Case Number: ZC-21-229

Zoning Map Amendment

Case Manager:	Sarah Bergman			
Owner / Applicant:	W. Chang Family LP & C. Chang / Jackson Walker LLP			
Site Location:	10100 - 1	300 blocks Blue Mound RoadAcreage: 55.08 acres		
Request				
Proposed Use:	Multifami	Multifamily Dwellings (mix of attached and detached units)		
Request:	From: "AG" Agricultural			
	To: "PD/C" Planned Development for all uses in "C" Medium Density Multifamily including detached multifamily, with specific development standards for setbacks, fencing, open space, parking and driveways between buildings and a public street, and building orientation; site plan included			
		Recommendation		
Land Use Compatibili	ty:	Requested change is compatible.		
Comprehensive Plan Consistency:		Requested change is not consistent (technical inconsistency).		
Staff Recommendation:		Approval of revised site plan submitted during Zoning Commission hearing.		
Zoning Commission:		Approval as Amended by a vote of 7-2 (to include revised site plan)

JOB NO. 21086

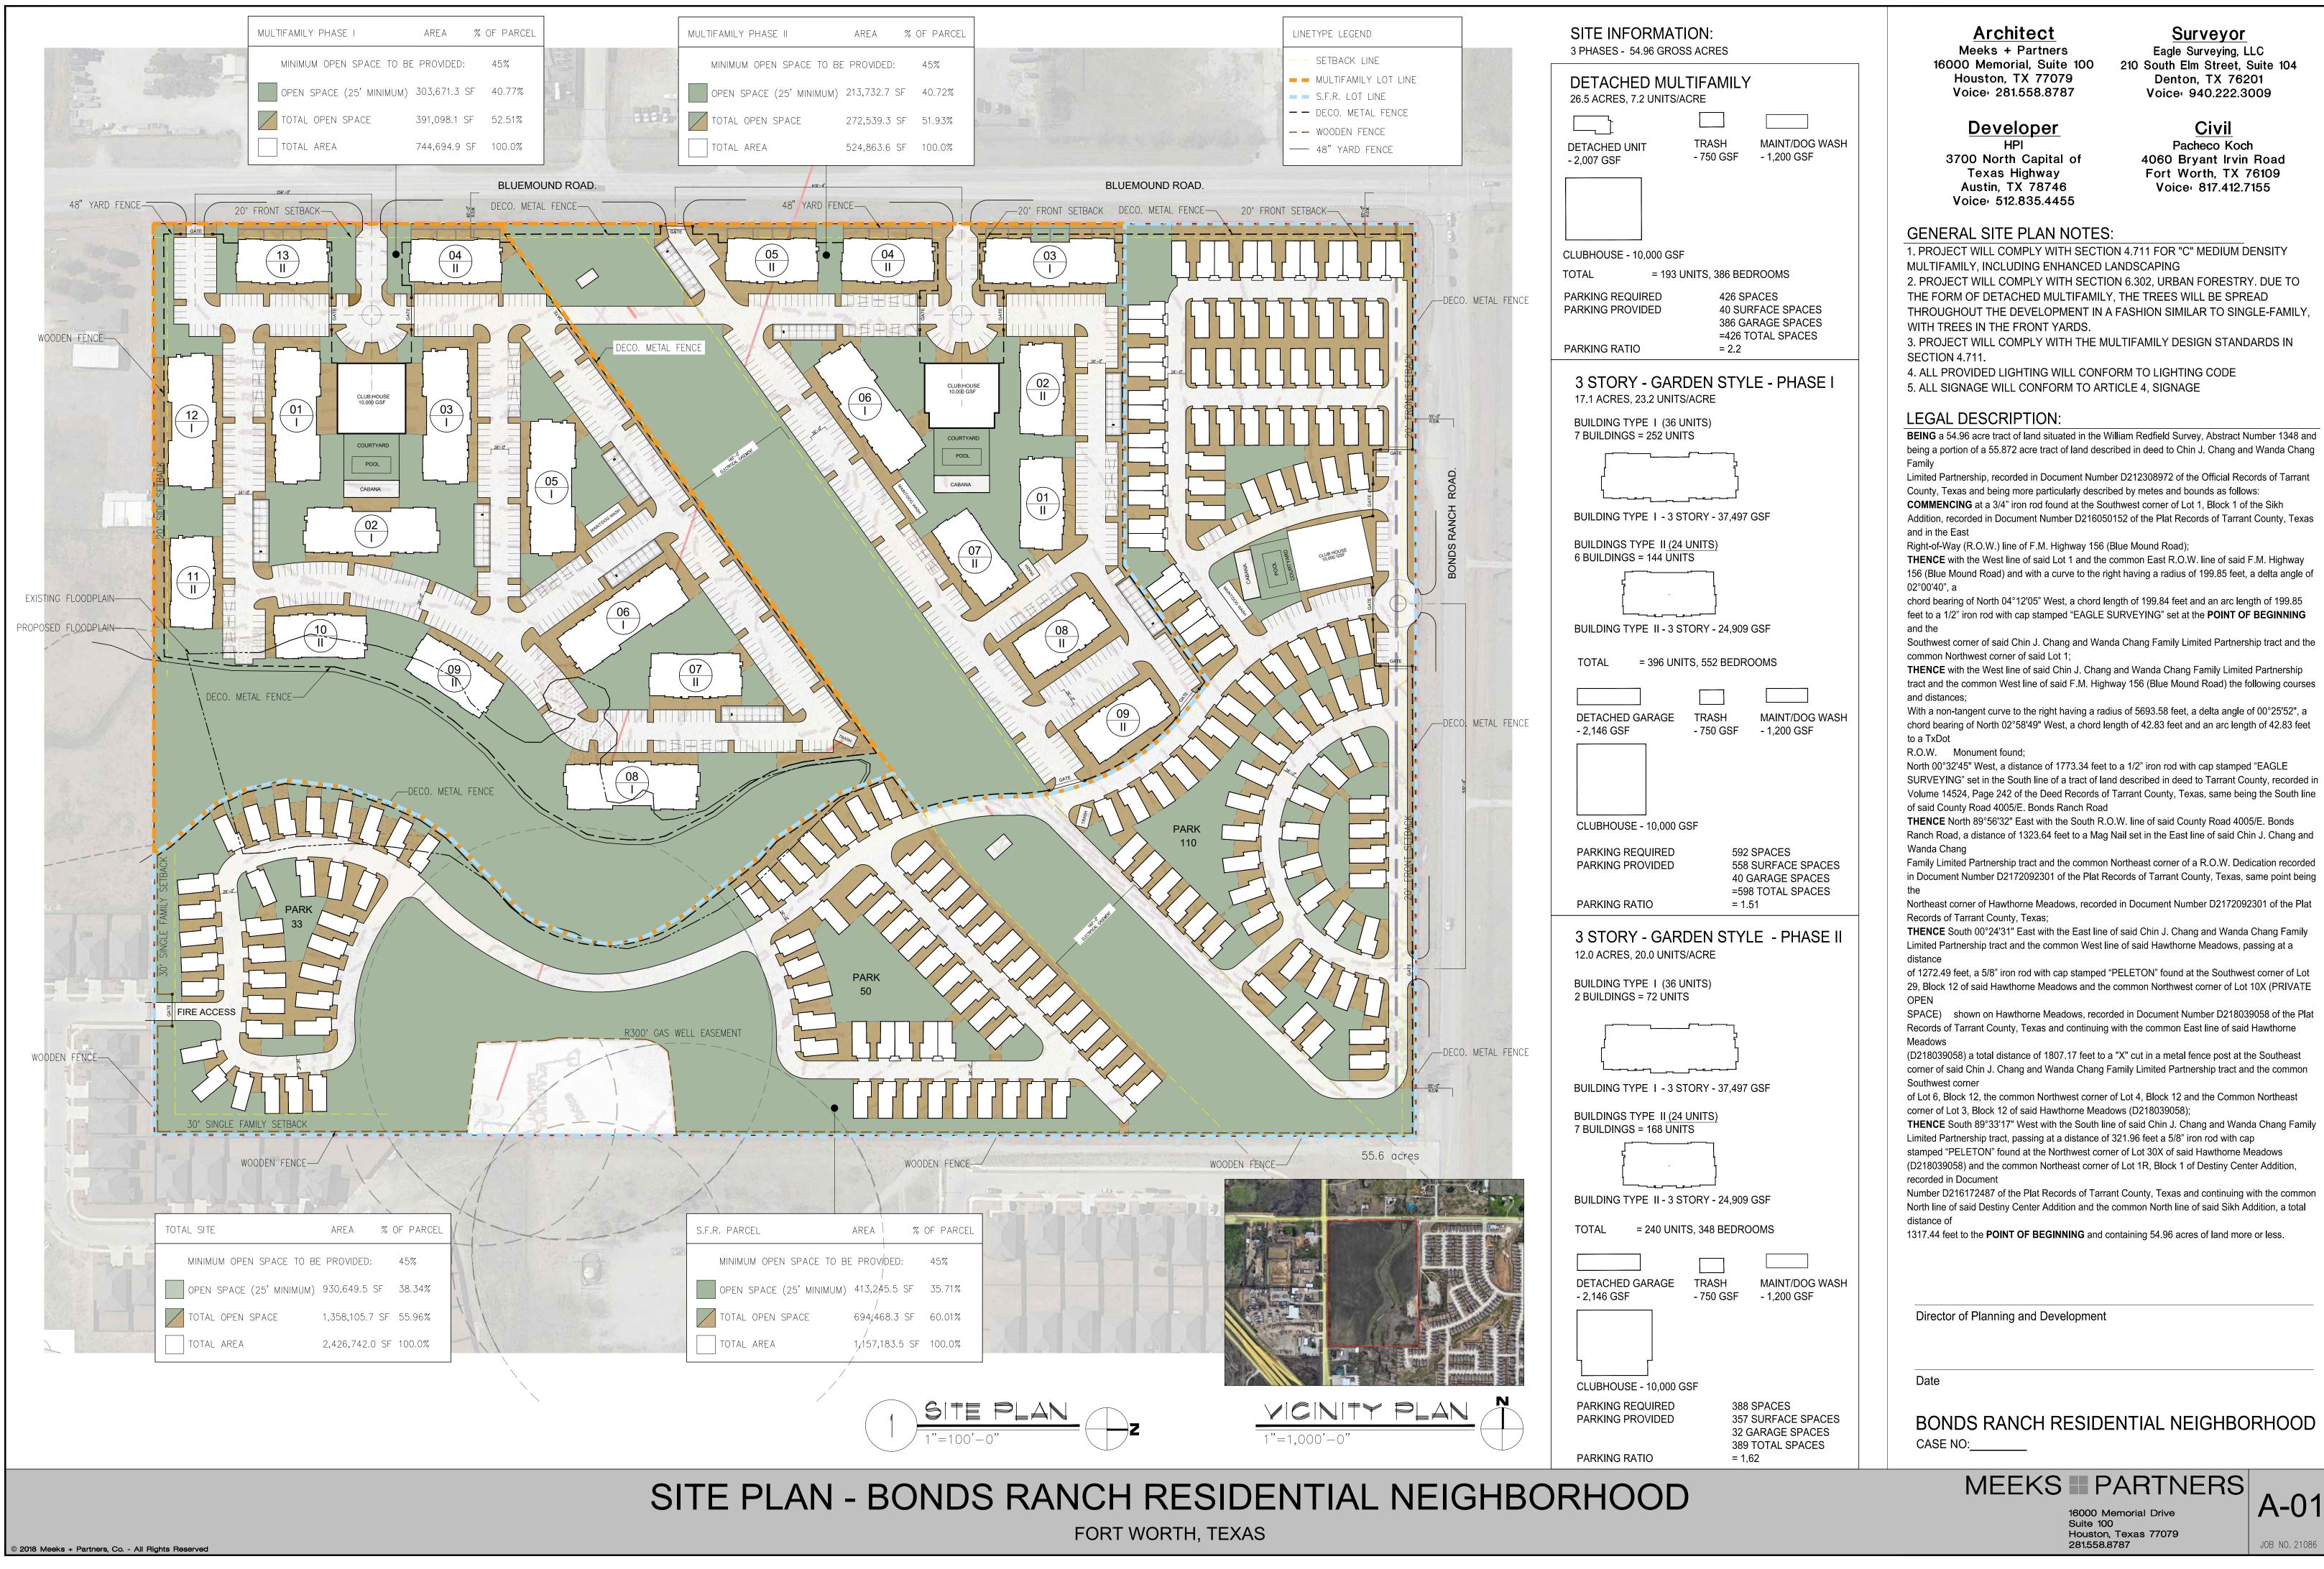
Analysis: A drive aisle is shown on the site plan between the detached multifamily buildings and Bonds Ranch Road. The layout along Blue Mound Road complies with ordinance requirements. Staff is supportive of this request, as the form of detached multifamily is significantly different than traditional multifamily, with smaller buildings that are not oriented towards the right-of-way.

Analysis: An open-style metal fence is proposed between the detached multifamily buildings and Bonds Ranch Road. Fencing along Blue Mound Road will comply with standard ordinance requirements, which allows for four-foot fencing to extend beyond the building façade for private residential patios and yards.

Analysis: The minimum open space requirement for "C" Medium Density Multifamily is 45%. The applicant has provided a comparison on the site plan showing the open space provided for each phase of development when calculated under standard ordinance requirements, as well as when areas less than 25-ft in either direction are included. For the two standard multifamily phases, approximately 41% open space is provided under standard ordinance calculations and 52% is provided when areas less than 25-ft are included. For the detached multifamily phase, approximately 36% open space is provided under standard of multifamily phase, approximately 36% open space is provided under standard requirements, and 60% is provided when areas less than 25-ft are included.

Analysis: All buildings in the traditional multifamily phases are oriented correctly, with the longest side of the building facing the street. A waiver is requested to allow the detached multifamily units to have the shorter length of the building facing the street.

- FYI Comments:
 - Walkways shall be provided to connect to all buildings, parking areas and recreational facilities and shall be shown on the site plan. Walkways shall connect to public streets where street frontage exceeds 500 feet and to adjacent public property, commercial areas, and trails.
 - Documentation will be required for any parking, drive aisles, or fencing within the electrical easement during building permit review.
 - Areas used for credit towards enhanced landscaping requirements cannot be counted towards minimum open space requirement.

- Two approved points of access must be provided for each phase.
- Fire lanes crossing flood plain but be constructed to city street standard.

- Subdivisions shall be designed to connect to adjacent existing stub-out streets as provided on any approved preliminary or final plat. There are two existing stub outs that require a variance to not connect.
